APPROVING REQUEST FROM TEMPLE PARTNERS, LP FOR A CERTIFICATE OF APPROPRIATENESS TO ALLOW CONSTRUCTION OF A SIX-FOOT-TALL BLACK ORNAMENTAL FENCE AND GATE IN THE REAR OF THE MASONIC TEMPLE LOCAL LANDMARK AT 1101 LOCUST STREET

CITY OF DES MOINES LANDMARK REVIEW BOARD
STAFF REPORT AND RECOMMENDATION
Tuesday, October 3, 2023

CAHP-2023-000098

PROPOSED EAST
FENCE + GATE

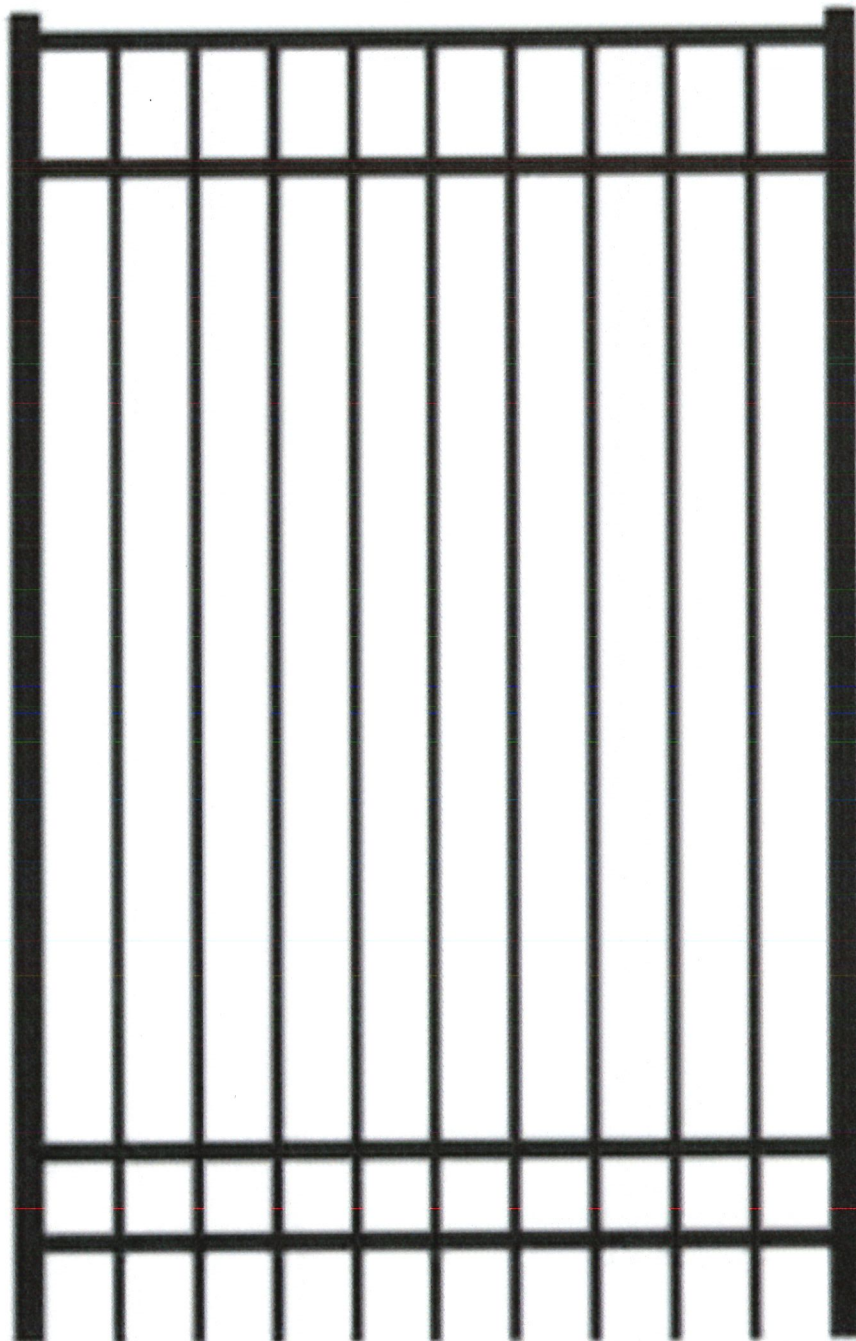
Specifically, the fencing and gates on the east side of the restricted area (adjacent to and visible from 10th Street) intend to run parallel to and utilize the fire egress structure. As such, staff believes a fence/gate design that matches the existing fire egress stairs and screening in design, materials, and height would be most appropriate for this location. Such a design would be compatible with existing structures and increase overall screening on a street-facing façade. Additionally, this design would allow more flexibility to accommodate any necessary adjustments in gate width to accommodate building and fire codes for egress from the upper floors.

Staff supports the introduction of fencing around the service area but does have concerns that the new fencing and gate design will not appropriately integrate with the adjacent existing screening and egress stair.

It was noted that staff believes a fence/gate design that matches the existing fire egress stairs and screening in design, materials, and height would be most appropriate for this location.

1. Fencing along the east entrance shall match the existing fire egress screening in design, materials, height, and color to the extent possible.
2. Fencing along the west entrance shall not attach directly to the Masonic Temple building.
3. Compliance with all applicable Building and Fire Codes as necessary with the issuance of a fence permit from the Permit & Development Center.
4. Review and approval of the finalized design and materials by the Planning and Urban Design Administrator.

PROPOSED
WEST
GATE

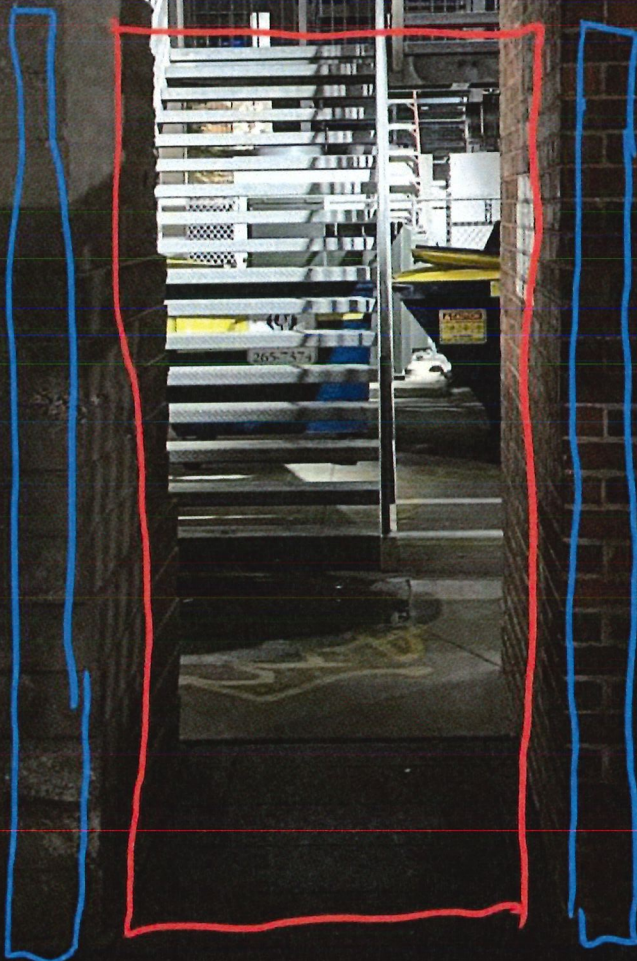
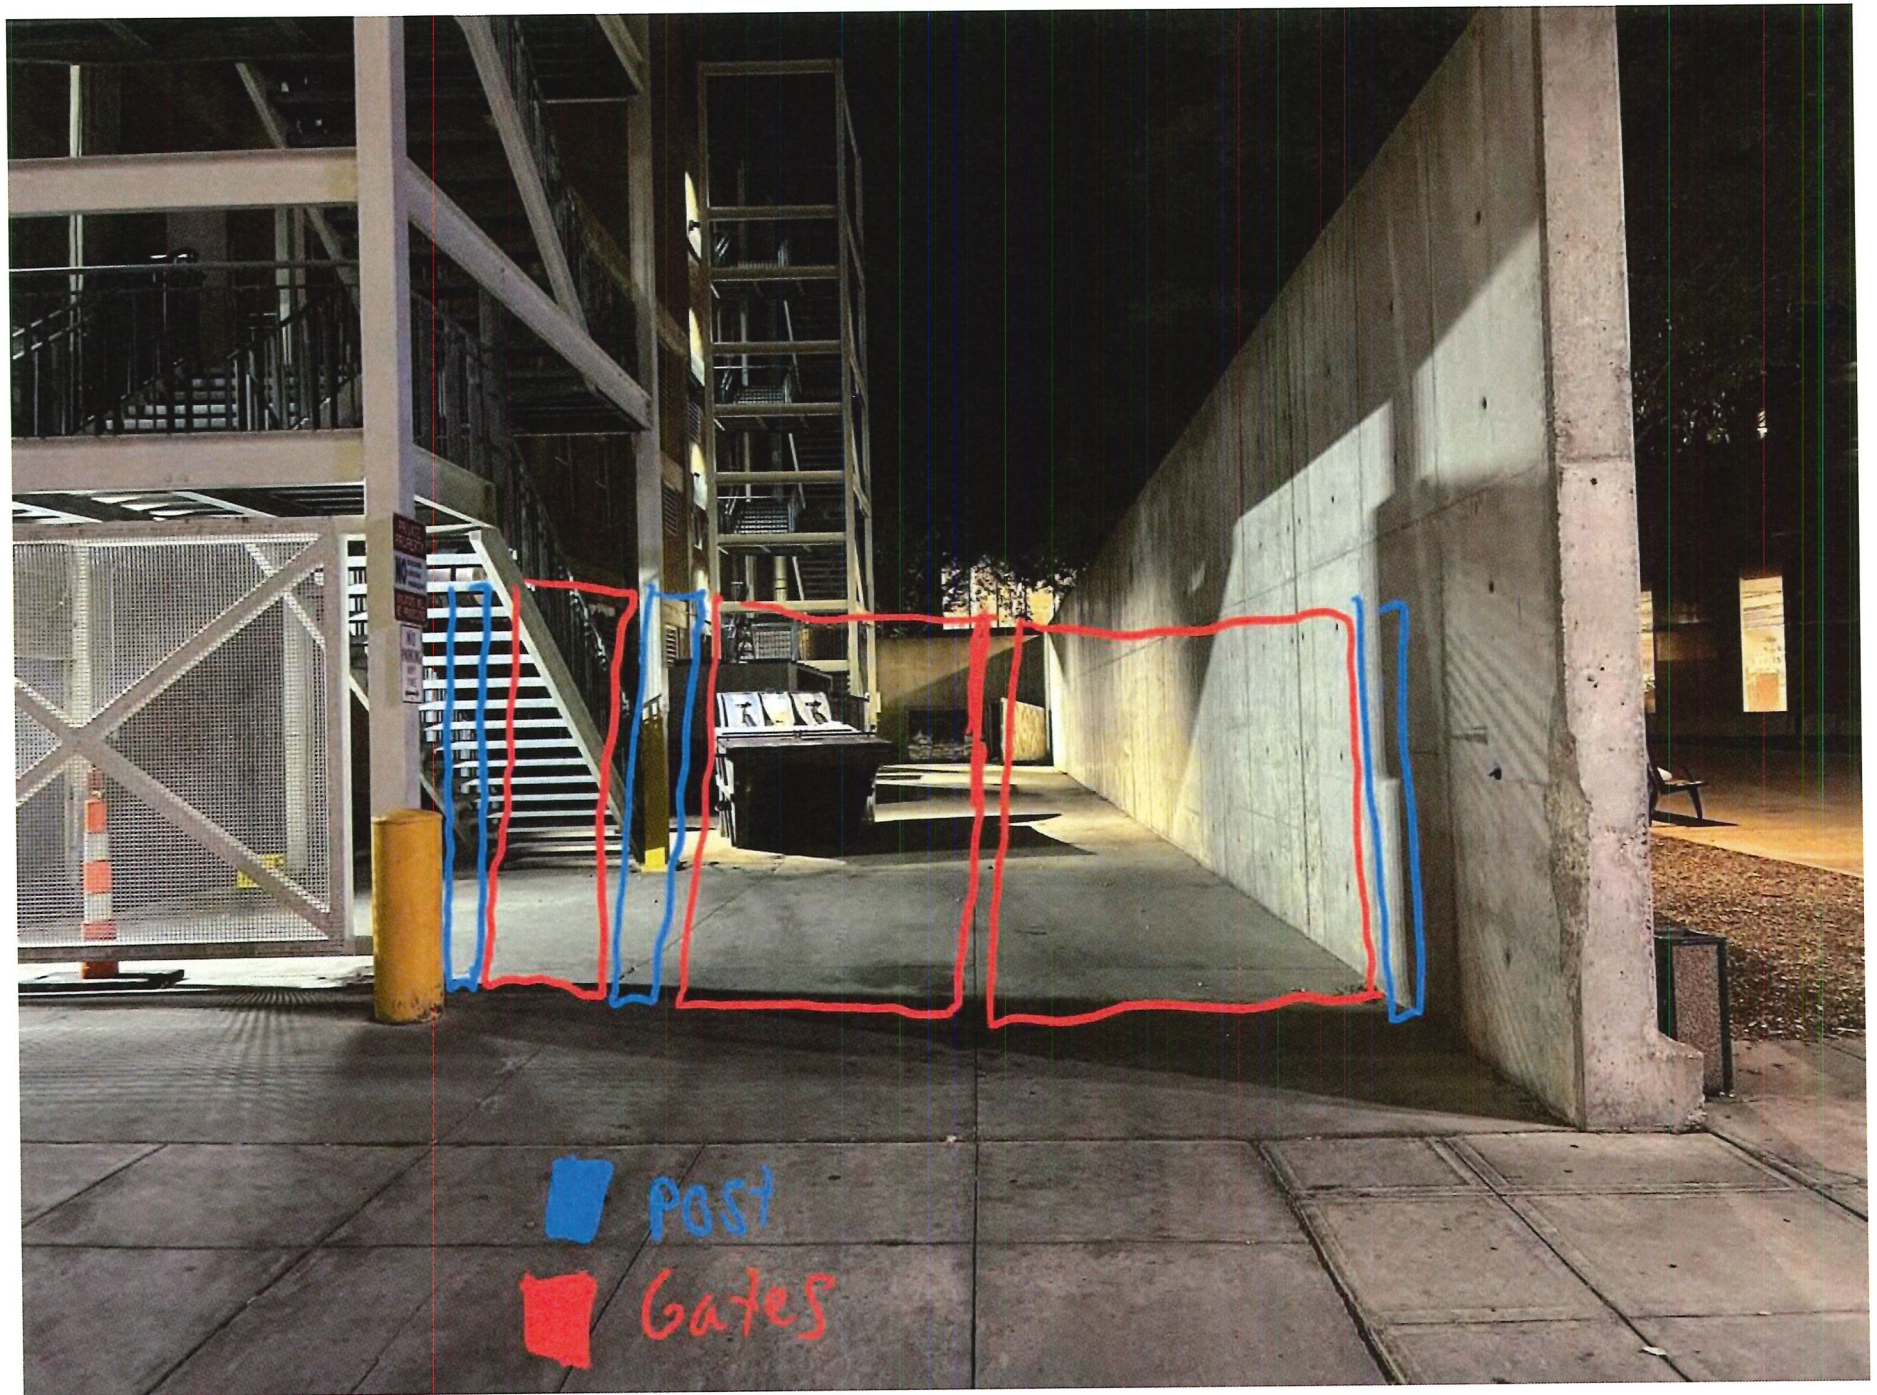
On the west side, all new fencing would be limited to a small, approximately 3-foot 6-inch-wide opening between the northwest corner of the Masonic Temple and the west terminus of the concrete wall that is not visible from Locust Street. On this side, staff supports use of black ornamental fencing, but would add a condition that the fencing, posts, or any other related infrastructure does not directly attach to the Masonic Temple to avoid unnecessary damage to the building. As recommended, staff finds the new fencing would meet the intent of Standards #9 and #10.

Staff supports the use of black ornamental fencing on the west side. All new fencing would be limited to a small, approximately 3-foot 6-inch-wide opening between the northwest corner of the Masonic Temple and the west terminus of the concrete wall that is not visible from Locust Street.

- On west side consider picking up same material so it appears to be more like a door than an open grate. People may understand that it is a egress if it is similar to the other side. May be more helpful to have more of a screen than a picketed fence. This could help with having a flat area to mount the panic hardware.
